**CITY OF PORTLAND, MAINE  
Portland Exposition Building Drainage Improvements  
Bid #5709**

**Current Date: March 11, 2009**

**NOTE: The following is a response to questions recently received on this bid:**

**TYPICAL CATCH BASIN**  
N.T.S.

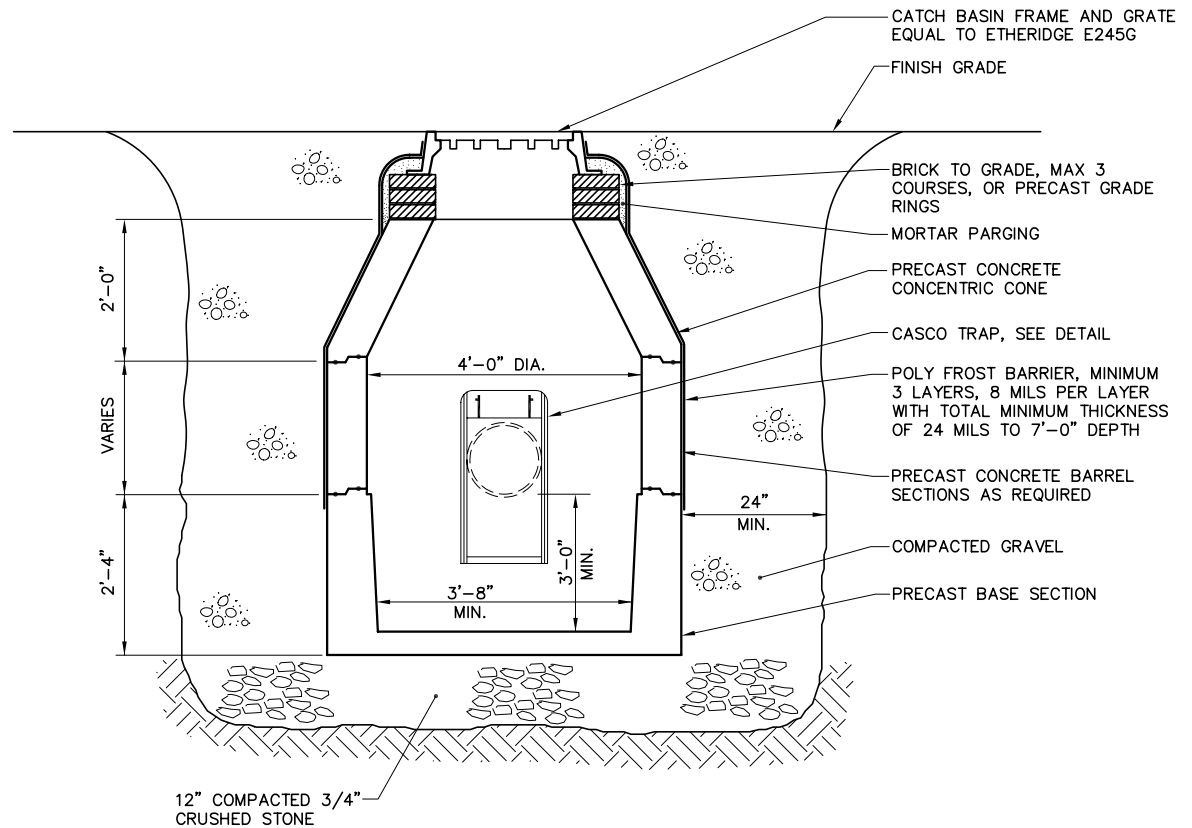
Sheet C-01: New Catch Basin shall be per attached Typical Catch Basin Detail, and in accordance with City of Portland Manhole and Catch Basin General Notes.

1. BOLT AND NUT REQUIRED WHERE HOOD WILL NOT OPEN COMPLETELY
2. 18" CATCH BASIN TRAP SHALL BE NEENAH FOUNDRY R-3701-18, OR EQUAL
